UNITED STATES PATENT AND TRADEMARK OFFICE

APPLICATION NO.	FILING DATE	FIRST NAMED INVENTOR	ATTORNEY DOCKET NO.	CONFIRMATION NO.
10/594,315	06/27/2007	Lawrence C. Kennedy	032968-0134	2098

Office Action Summary	Application No. 10/594,315	Applicant(s) KENNEDY ET AL.	
	Examiner RYAN DODD	Art Unit 3655

DETAILED ACTION

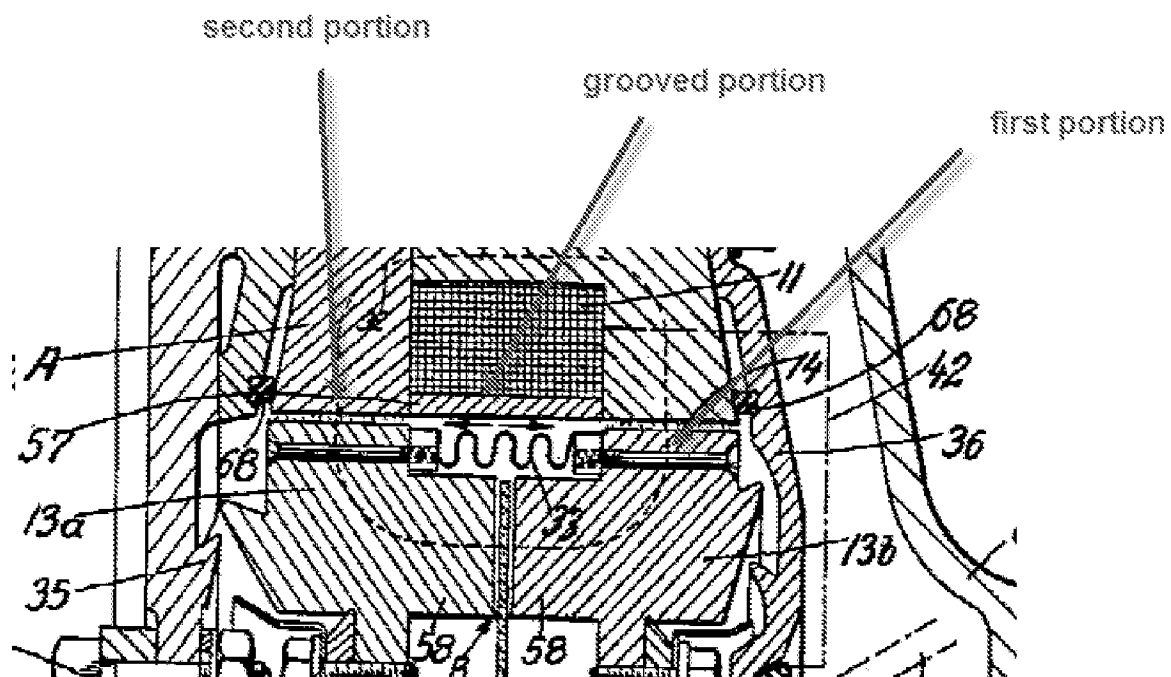
Forster '658 discloses, referring to Fig. 2, a viscous fluid clutch for use in a vehicle (column 1, line 18) comprising:

- a rotor (driven member 13) having a rotor hub (32 or hub members 30a,b) driven by an input shaft (shaft 17) and a rotor surface (facing gap 14) having an end connected to an outer periphery of the rotor hub (via rings 13a,b),

- the rotor surface including: a first portion; a second portion; and a grooved portion disposed between the first and second portions (See Fig. 2 and Fig. below);

- wherein the grooved portion forms a W-shaped profile, wherein a portion of the grooved portion which forms the W-shaped profile is formed by a single piece (springs 33 are formed by a single piece and are in the shape of multiple cursive W's);

- wherein the first and second portions of the rotor each have a thickness sufficiently greater than a thickness of the grooved portion such that a magnetic flux path in the fluid clutch will have a substantial portion of a magnetic field flow around the grooved portion as compared to a portion of the magnetic field flow that flows through the grooved portion. (See Fig. 2, dotted line, see also column 4, lines 71-72)

As to claims 2 and 52, Forster '658 discloses a magnetorheological fluid clutch, comprising:

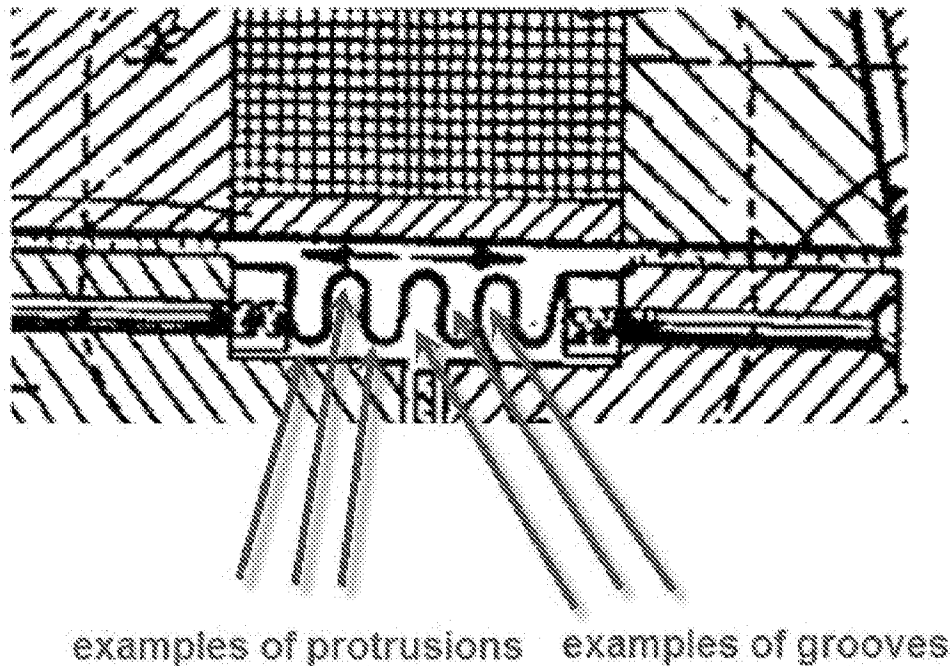
- an input shaft (shaft 17);
- a coil assembly (electrical coil 11) for generating a magnetic field;
- a housing comprising a stator (annular member 12); and
- a rotor (driven member 13) disposed in the housing;
- wherein the rotor includes a radially extending hub (32 or 30a,b) driven by the input shaft and an annular rotor ring (13a,b) connected to the hub; and
- wherein the rotor ring includes a first portion, a second portion, and a portion of reduced thickness (see Fig. 2 and figure below) disposed between the first and second portions to prevent a shunt in the magnetic field,
- wherein the rotor includes a grooved portion (springs 33) which forms a W-shaped profile at the portion of reduced thickness, wherein the grooved portion which forms the W-shaped profile is formed by a single piece.

As to **claims 4 and 5**, Forster '658 discloses: wherein the portion of reduced thickness is formed to include grooves and protrusions (see figure below), which form the W shaped profile.
